**1.2 NOS. 6 & 8 BELMONT AVENUE, CLAYTON - CONSTRUCTION OF A FOUR STOREY APARTMENT BUILDING WITH BASEMENT CAR PARKING**  
(TPA/54253)

**EXECUTIVE SUMMARY:**

This application proposes the construction of a four (4) storey building containing 28 apartments with a basement car park providing for 32 parking spaces.

That Council resolves to issue a **Notice of Decision to Grant a Planning Permit (TPA/54253)** for the construction of a four-storey apartment building with basement car parking, at 6 and 8 Belmont Avenue, Clayton subject to the following conditions:

DRAWING:  
Ground Floor Plan

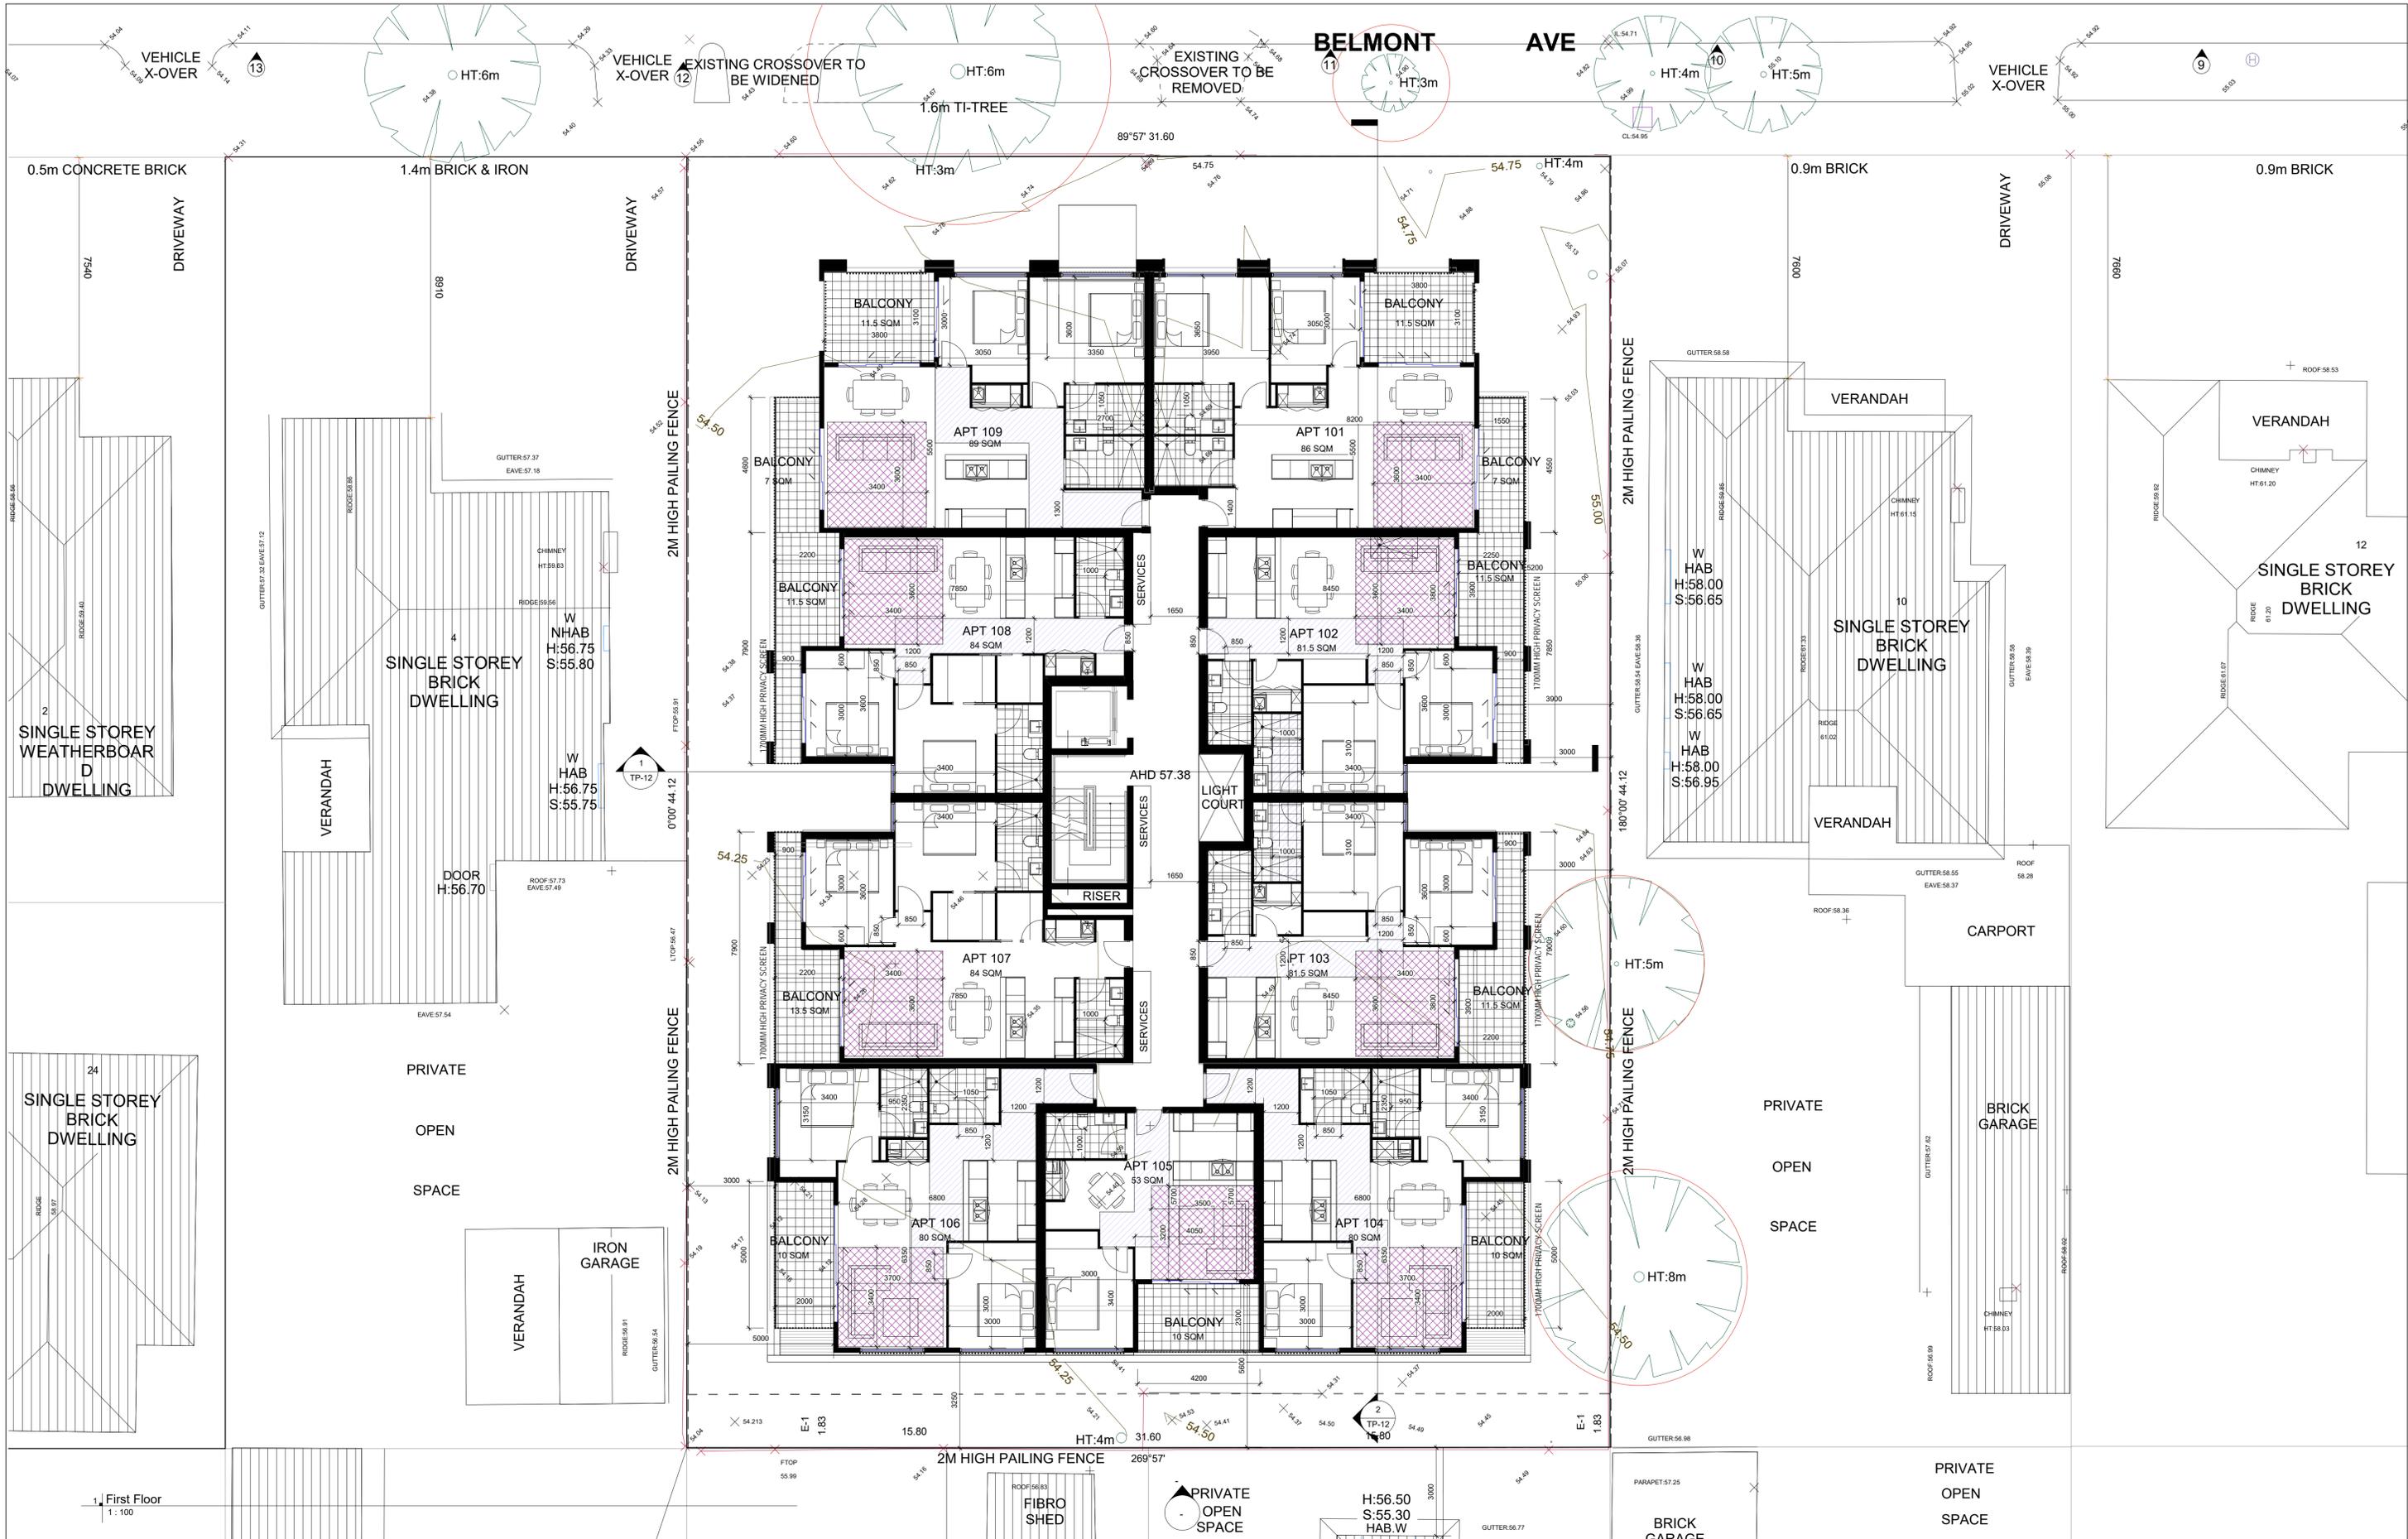
- b) Fencing on the eastern side of Apartment G01, to be located a minimum of 500mm behind the front wall of the building to enclose the secluded private open space area.

- c) Location of the substation/ electricity supply discreetly screened from the street by landscaping.
  - d) Inclusion of a notation on the ground floor plan to read 'a tree protection fence must be erected around all trees that are to be retained, including street trees and trees on neighbouring properties. The tree protection fence must remain in place until all construction is completed on the land, except with the prior written consent of the Responsible Authority'.

- e) Notation on the ground floor and landscape plan to read 'all trees to be retained (street trees and trees on neighbouring properties) shall be protected in accordance with the protection measures in the arborist report prepared by Glenn Waters (Version 2).
